Proposed Plan Change 2 (Regionally Significant Wetlands)

Officer's Report on Decisions Requested

Addendum to
Chapter 3:
Schedules and Maps

Inland Saline Wetland (Map F18)

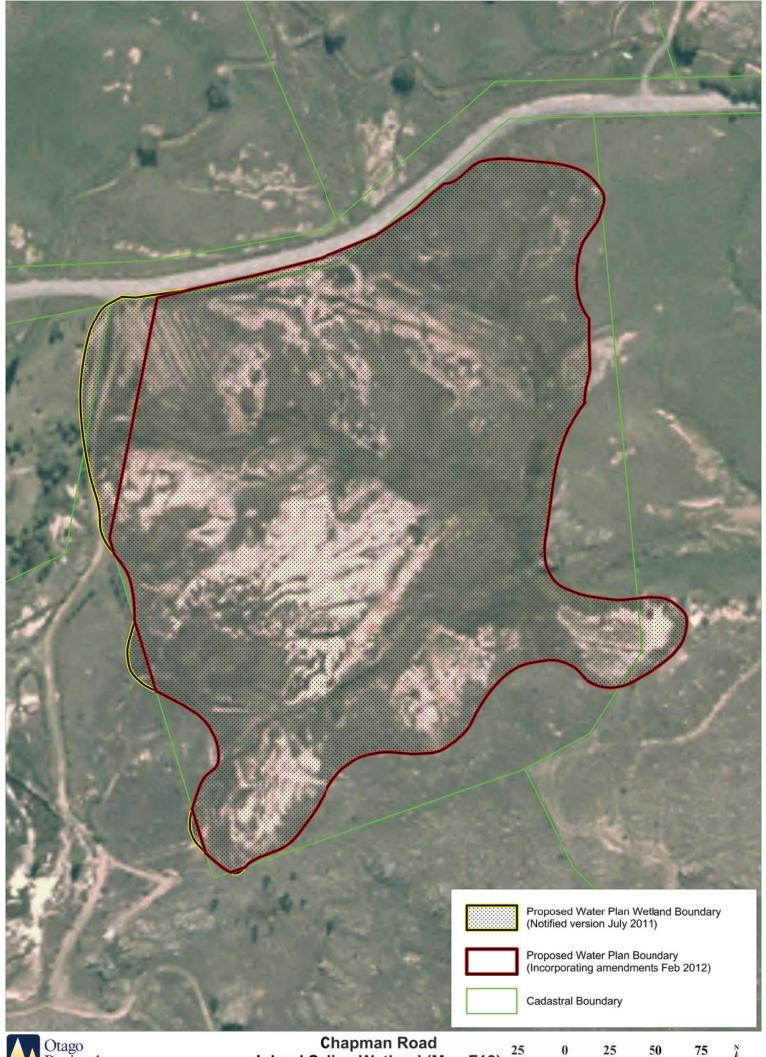
The majority of this wetland is located within a reserve administered by the Department of Conservation. However, the north-western boundary of the wetland currently encroaches onto a driveway in the adjacent property.

A site visit was carried out by an ORC officer in December 2012. This visit identified the driveway area as "highly modified", with "no evidence of a natural ecosystem in place. Three other areas were identified where the wetland boundary goes onto the adjacent property. The site visit identified that it was "better suited to align [the wetland boundary] with the property boundary line". The proposed wetland is approximately 7.4ha, while the three areas on the adjoining property add to approximately 0.0319ha (or 319sam).

- A site visit to Chapman Road Inland Saline Wetland found the proposed wetland boundary encompassed a driveway which was not a wetland area. This wetland is predominantly on a Department of Conservation reserve. Aligning the wetland boundary with the property boundaries is unlikely to impact on the wetland hydrology or values.

- a) Amend the wetland boundaries in the proposed F-series of the Maps as shown in Appendix 1:
 - Akatore Creek Swamp
 - Waipori/Waihola Wetland Complex
 - Chapman Road Inland Saline Wetland
 - Diamond Lake Wetland
 - Lake Reid Wetland
 - Three Stones Fen Complex
 - Pleasant River Estuary Wetland Complex
- b) Retain the wetland boundary of Stirling Marsh Complex in the proposed F-series of the Maps as recommended by Wildland Consultants Ltd.
